From: James Cross <James.Cross@arun.gov.uk>
Sent: 25 February 2021 14:37
To: Planning.Responses <Planning.Responses@arun.gov.uk>
Subject: FW: BN/135/20/PL - Boweries

From: Stephen Gee [REDACTED]
Sent: 25 February 2021 10:24
To: Kerry Simmons [REDACTED]
Cc: James Cross <James.Cross@arun.gov.uk>
Subject: RE: BN/135/20/PL - Boweries

Kerry,
Comments on the additional plans provided.

Greenway linkage to Barnham Road

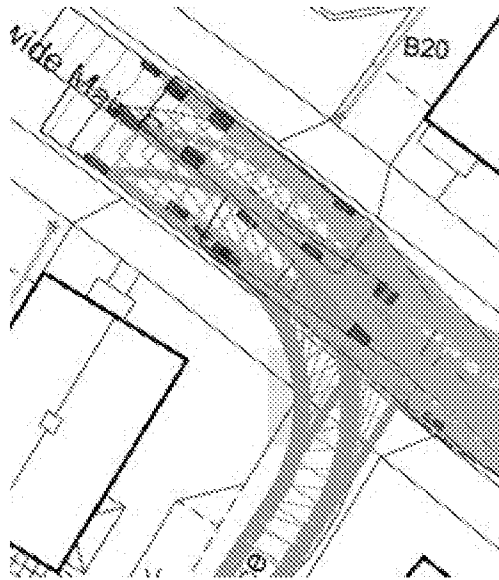
The proposed plan only shows dropped kerbs for cyclist to exit westbound, consideration should be provided to allow all movements and consider the wider connectivity to the north.
